UNITED STATES PATENT AND TRADEMARK OFFICE

10/613,786

Office Action Summary	Application No. 10/613,786	Applicant(s) PEARSON	
	Examiner Michelle (Shelley) Clement	Art Unit 3641

DETAILED ACTION

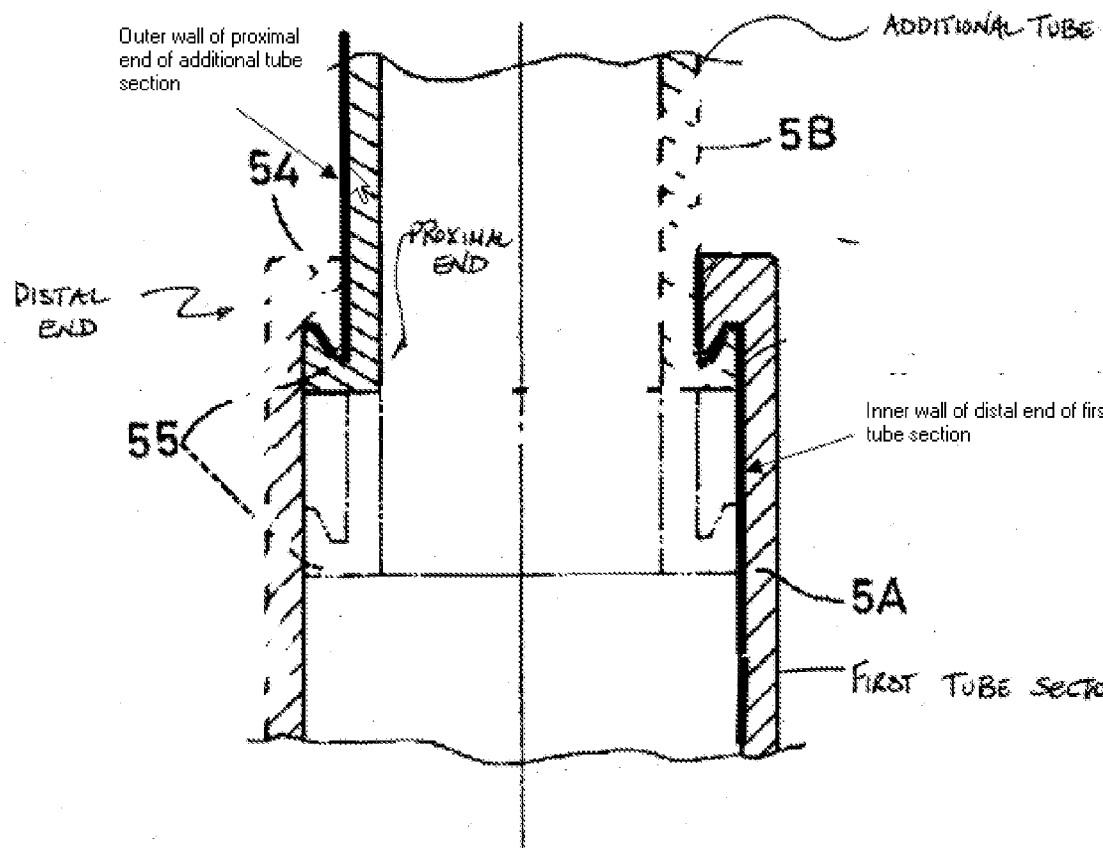
1. Applicant's arguments filed 6/25/0 have been fully considered but they are not persuasive. Applicant's arguments amount to a general allegation that the claims define a patentable invention without specifically pointing out how the language of the claims patentably distinguishes them from the references. Initially applicant contends that claim 12 has been amended to make clear that it is the inner diameter and the outer diameter of the respective tube sections that are in direct contact. However this is not exactly the claim language, it is noted that claim 12 recites "the outer **wall** of the proximal end of the at least one additional tube section directly contacts the inner **wall** of the distal end of the first tube section". From the figures of Lin it is clear that the outer **wall** (of the proximal end of the additional tube section) directly contacts the inner **wall** of the distal end of the first tube section. From the figures these sections are clearly in direct contact at the claimed points. It is further noted that the outer wall constitutes the **entire** outer wall (i.e. surface) of the tube and not just a single point on the tube as applicant appears to be arguing. Applicant's arguments concerning the terms "inner" and "outer" as they relate to being "farther in" or "farther out" are not applicable in the situation where the two diameters do not have a common reference point. The inner diameter of the inner wall of one tube section is not required *by definition* to be "situated farther in" than an outer diameter of an outside wall of *a completely separate tube*. In such a case it is the configuration of the elements in the claim language that determines if the claimed "inner" is "farther in". Regardless, in the current situation Lin shows that the inner wall (for instance where applicant has shown the dot and the terms "inner diameter") of the distal end of the first tube section is situated "farther in"

(toward the axis of the tubes) than the outer diameter (for instance where applicant has shown the dot and the terms “outer diameter”) of the proximal end of the at least one additional tube section. In response to applicant's argument that the references are nonanalogous art, it has been held that a prior art reference must either be in the field of applicant's endeavor or, if not, then be reasonably pertinent to the particular problem with which the applicant was concerned, in order to be relied upon as a basis for rejection of the claimed invention. See *In re Oetiker*, 977 F.2d 1443, 24 USPQ2d 1443 (Fed. Cir. 1992). In this case, the references are in the same field of endeavor. In response to applicant's arguments against the references individually, one cannot show nonobviousness by attacking references individually where the rejections are based on combinations of references. In regards to applicant's remarks concerning the Strodtman reference, it is noted that the reference is relied upon for the teaching of the tapering of the telescoping tube sections, it is the suggestion of Strodtman that is combined with the additional references that is relied upon for the current rejection (Strodtman is not relied upon for teaching of a material and applicant has claimed a specific material). See *In re Keller*, 642 F.2d 413, 208 USPQ 871 (CCPA 1981); *In re Merck & Co.*, 800 F.2d 1091, 231 USPQ 375 (Fed. Cir. 1986).

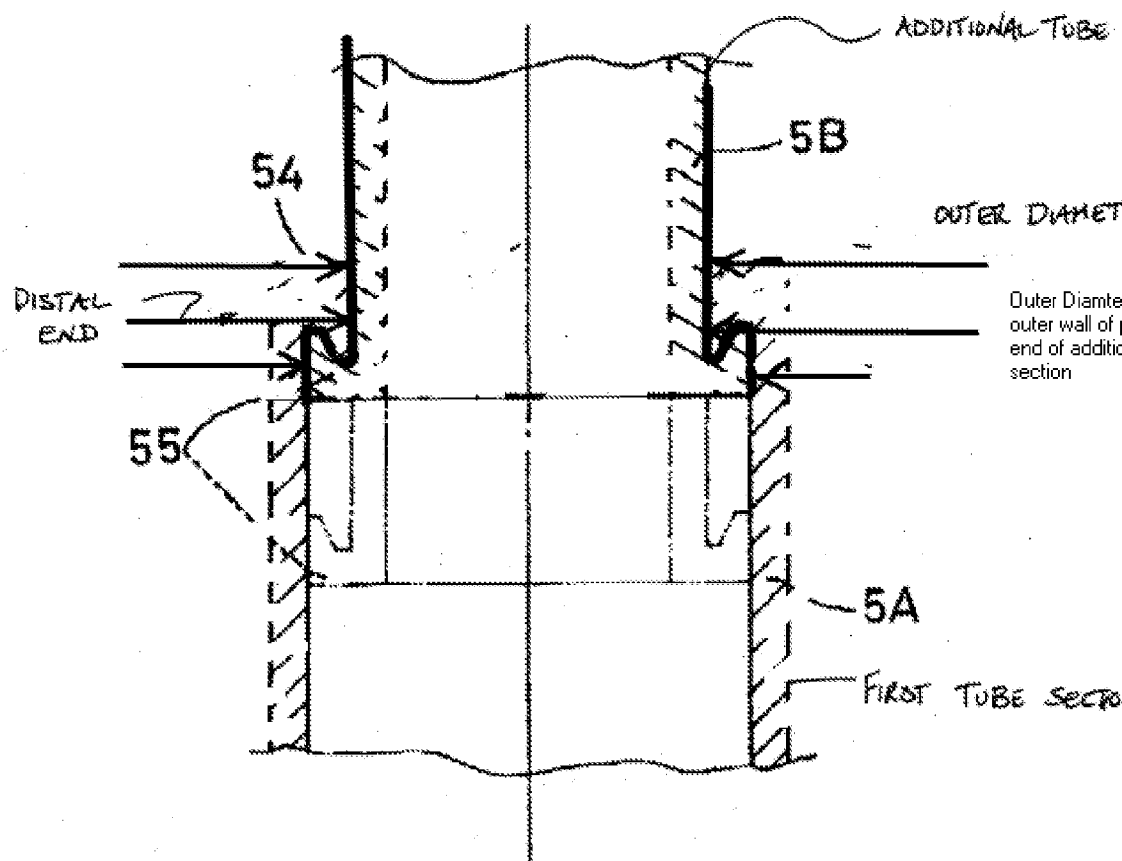
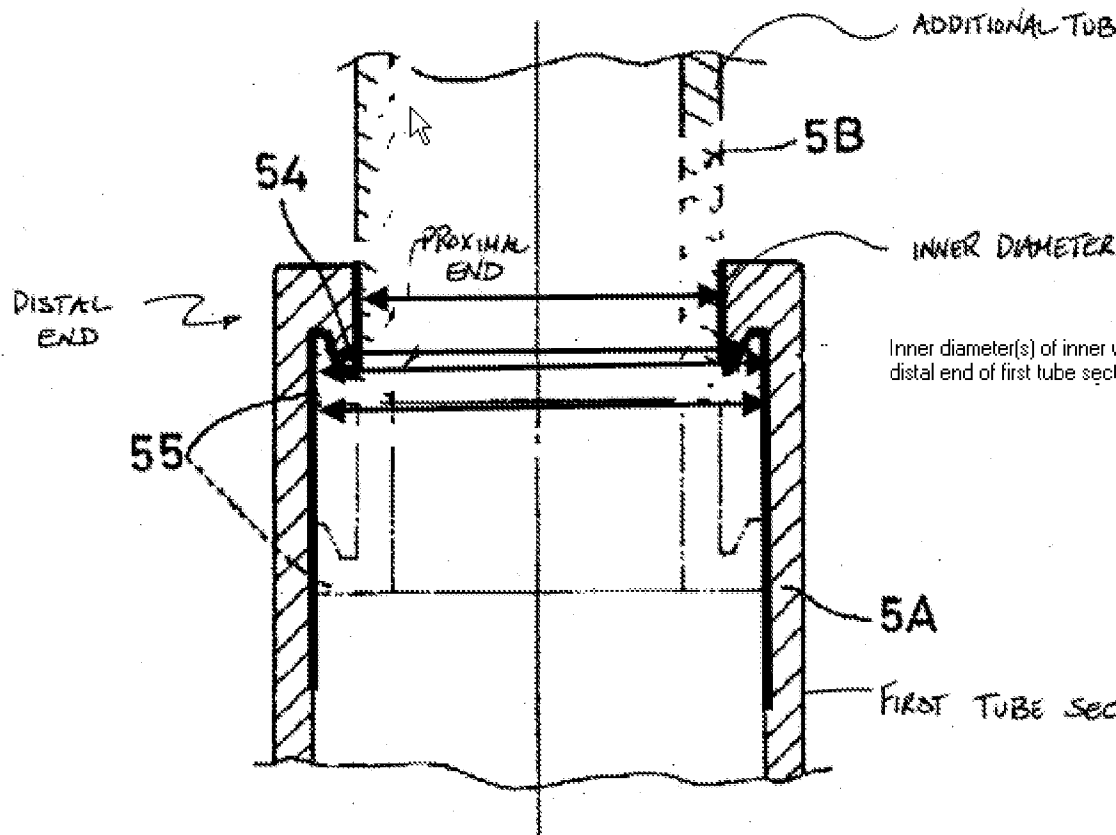
3. Claims 12 and 22-24 are rejected under 35 U.S.C. 103(a) as being unpatentable over Lin (US Patent # 6,091,597), Larsen et al. (US Patent # 3,362,711), Henderson et al. (US Patent # 3,998,459) and Strodtman (US Patent # 5,287,255). Lin discloses a shock defense device comprising a first tube section (reference 4 and 5A) comprising a power source (column 3, lines 10-14) electrically connected to a high voltage generator, a first tube section (reference 5B) having a base section and a distal end, at least one additional tube section (references 5B and 5C) having a proximal end and a distal end and being disposed within the first tube section (column 3, lines 14-25), the proximal end of the at least one additional tube section having an outer diameter that is larger than the inner diameter of the distal end of the first tube section (Figures 10A and 11) (See examiner's notes on Figure 11 (the bolding references the respective inner and outer walls and thereby the respective inner and outer diameters) below clearly showing that the proximal end of the at least one additional tube section has an outer wall having an outer diameter that is larger than the inner diameter of the distal end of the first tube section, it is noted that wedge portions 54 and 55 are part of the tube sections and therefore part of the diameter of the tube sections that constitute the inner and outer diameters of the tube sections, when these two sections directly contact with each other as shown in figure 11 the direct contact between the outer wall and the inner wall causes the two sections to lock, i.e. they frictionally connect, the fact that they additionally have a normal force between them is irrelevant) and having a connection means to connect to the first tube section, said distal end comprising a conductive probe (references 53, 53' or 121), for delivering a high-voltage shock, electrically connected to the output of the high voltage generator (column 3, lines 1-25), and deployment means (column 3, lines 14-20) to extend the at least one additional tube section from its position as being

disposed within the first tube section to an extended position the proximal end of the at least one additional tube section frictionally connects to the distal end of the first tube section (Figures 10A and 11). The device comprising a first conductive lead (references 51 and 51' and 121(+ & -)), placed along the length of the exterior of the first tube section, electrically connected to the output of the circuit. The device further comprising a second conductive lead being placed along the length of the exterior of the at least one additional tube section (references 52 and 52' and 121 (+ and -)). The conductive probe is electrically connected to the output of the circuit through the first conductive lead (column 3, lines 14-65).
